DESIGN REVIEW BOARD WORK SESSION

Design Review Board Case # 2020-00001

Block P – 765 John Carlyle – North Tower and Podium

NORTH TOWER AND PODIUM
DESIGN REVIEW BOARD SUBMISSION

GROUND FLOOR PLAN

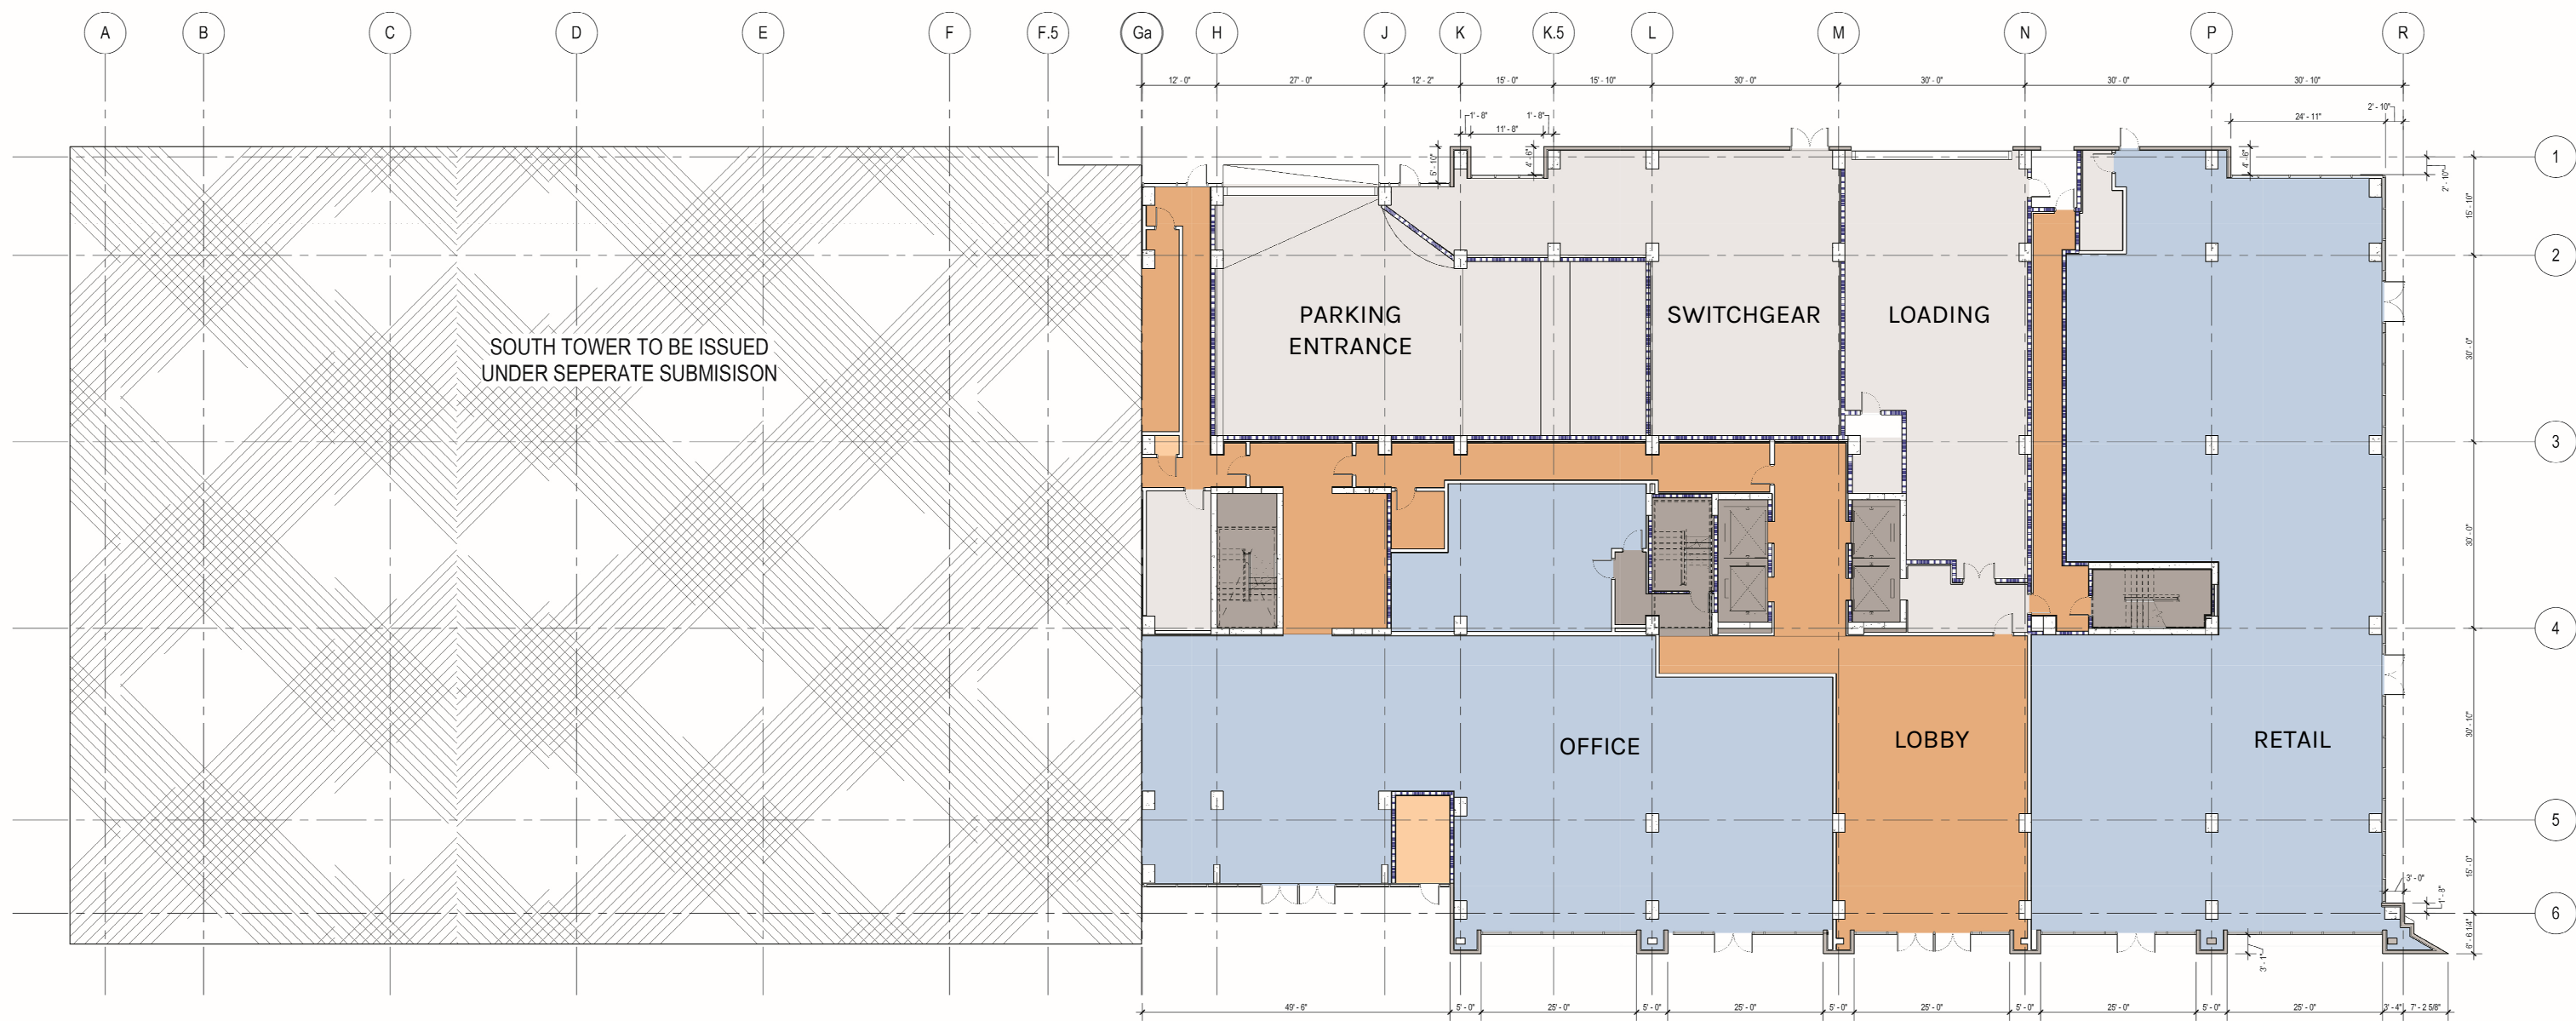
4. A representation is made of the south end of the north tower arcade on Sheet 24 that indicates a reveal separating the dark and light precast sections, and appears to indicate a projecting fin, but this is not reflected on any of the related floor plans (Sheets 7 & 8). This end could match the north end of the arcade or be different as shown, but details and dimensions must be shown and approved.

P2 LEVEL PLAN

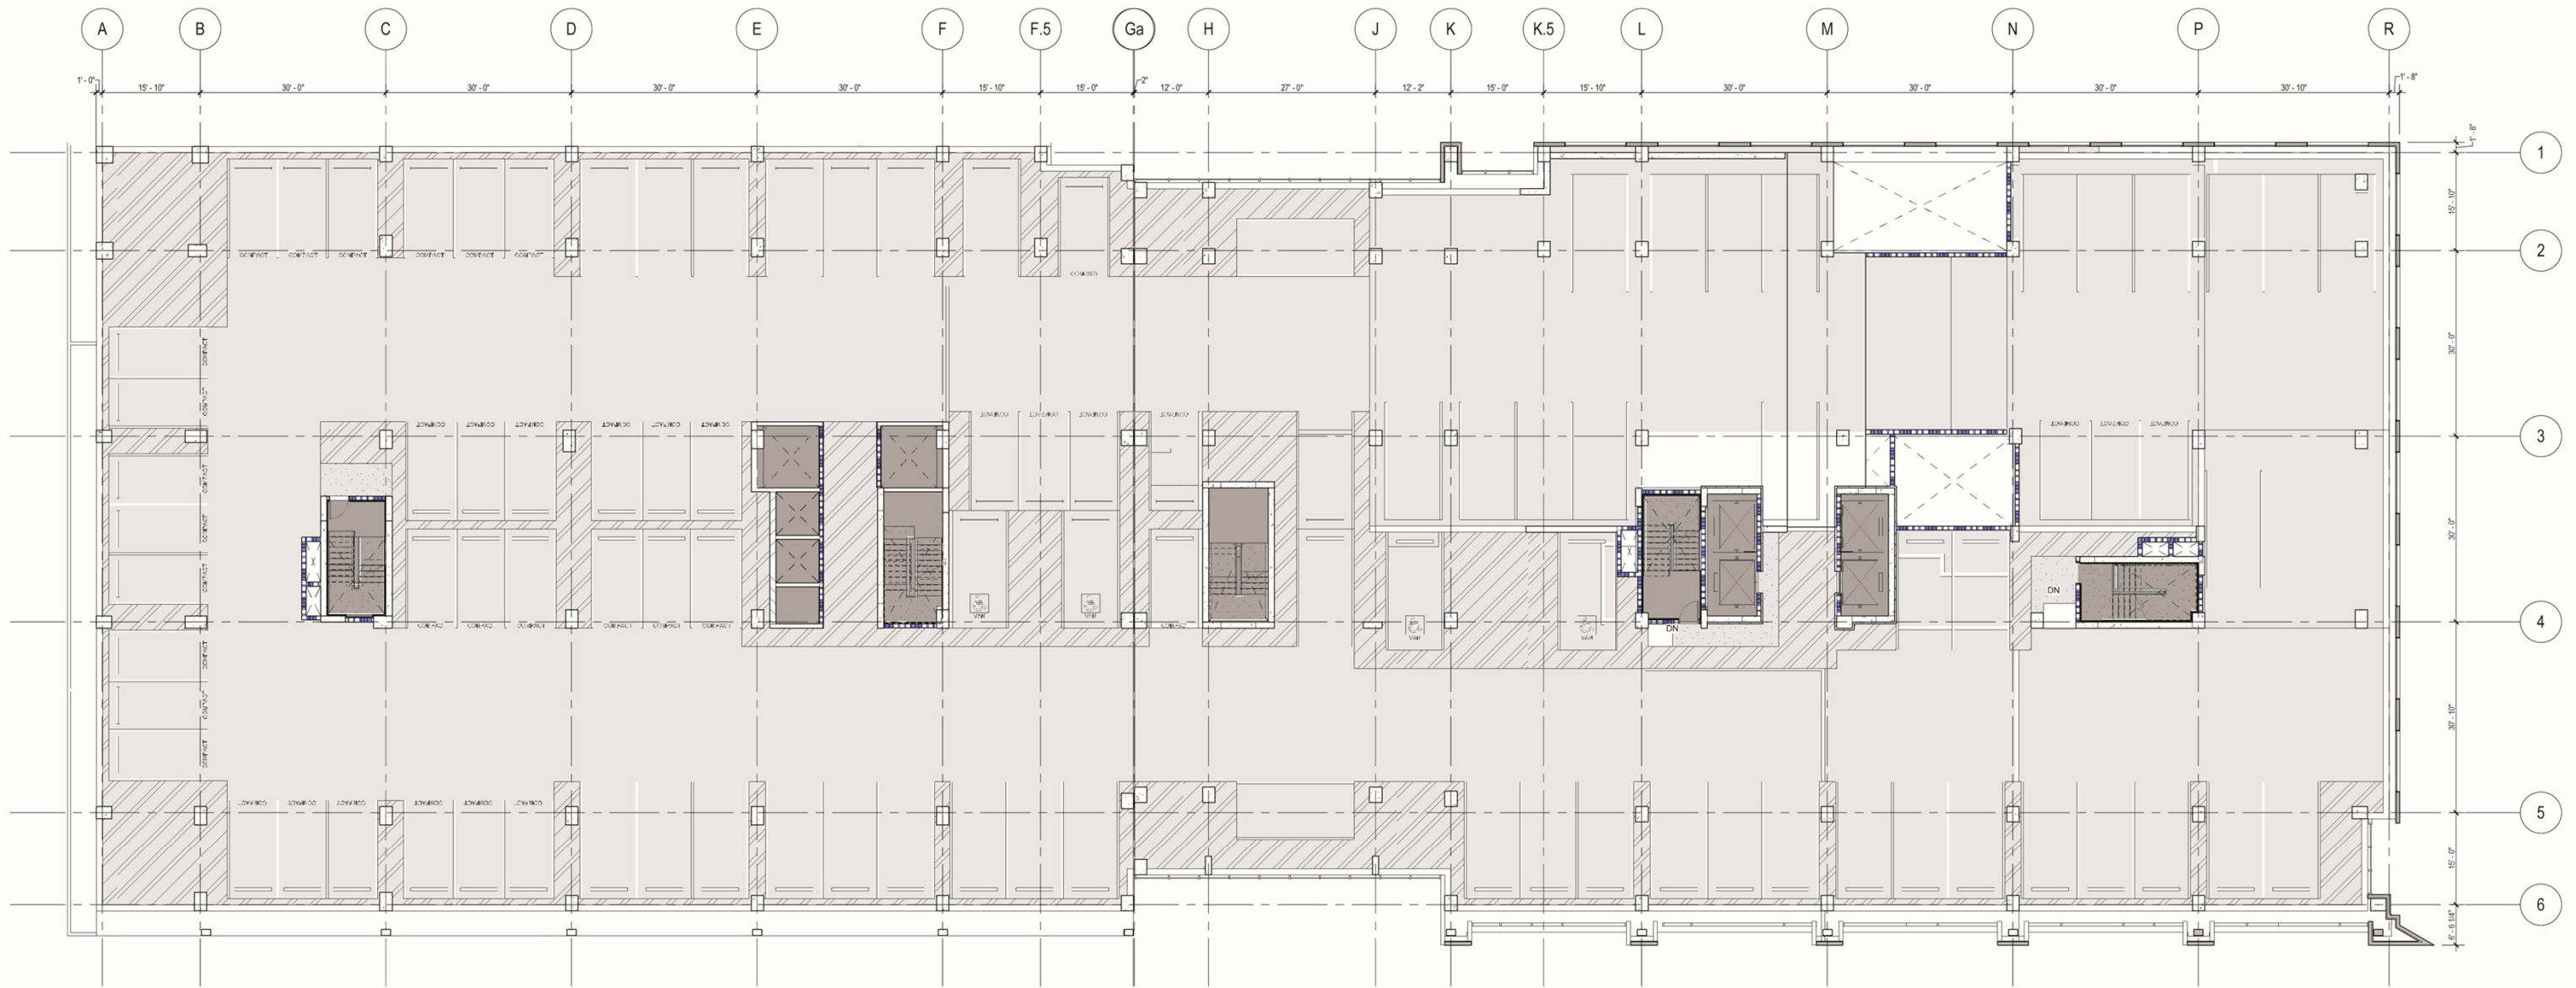
1. All non-back-of-house space on the ground floor must be designated as retail, as per the current approval and subsequent agreements. The architectural design of this ground floor must be provided to accomplish this, with regard to heights, configuration, ventilation, and other requirements suitable for retail and restaurant use. (Sheet 7)
2. Clearly show all vehicular circulation ramps in plan, including cut lines, dimensions, direction of slope, transitions, and slope percentages. (Sheets 8 & 9)
3. Show the proposed details for the glazing shown along John Carlyle Street at the P2 parking level – this needs to include accurate representations and mullion spacing on the P2 Level Plan (Page 8) and must also include fully-dimensioned large-scale plan-section-elevation

Staff is in agreement with the general glazing treatment of the north tower and podium. However, as previously intimated, further graphical details are required at final site plan to properly assess the materiality interface occurring at the P2 level.

Approved Grille Design at Parking Levels

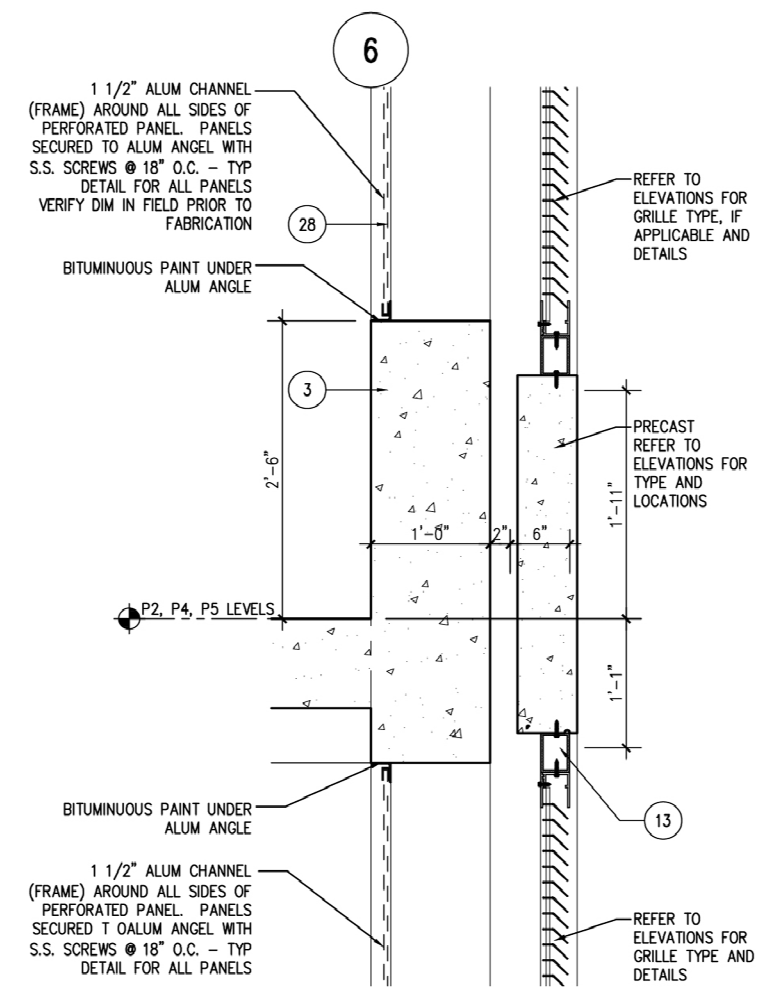
5. In reverting to the previously approved grille design for the above-grade parking levels P2-P5 along Hoof's Run Drive, Eisenhower Avenue, and P4-5 along John Carlyle Street, there is insufficient detail shown to render an approval (Sheet 31). Therefore, the following conditions of approval will have to be met by the applicant during Final Site Plan review, to the satisfaction of the Director, Planning & Zoning:

- a. Show large-scale, dimensioned plans-section-elevation representations of the Approved Grille Design
 - b. The horizontal, slightly recessed center section is shown clearly in the perspective view, but not shown at all in the vertical section drawing. There is an inner layer of screening shown in the section, but it is much further back from the front surface of the grille than is shown in the perspective view.

- c. In addition, there are no plan details shown on this sheet, or on any of the related floor plan sheets: this design incorporates a number of framed mullion conditions in plan and section, which need to be shown accurately on all floor plans, as well as in detail. Finally, some of the dimensions shown on the current partial section do not refer to elements in the drawing and appear to be mis-placed.

- d. During Final Site Plan review, include large-scale sections showing the above relationships from grade, up through the first office level floor, to accurately locate precast, grill, and glass-faces relative to each other. Additionally, quantify the setbacks.
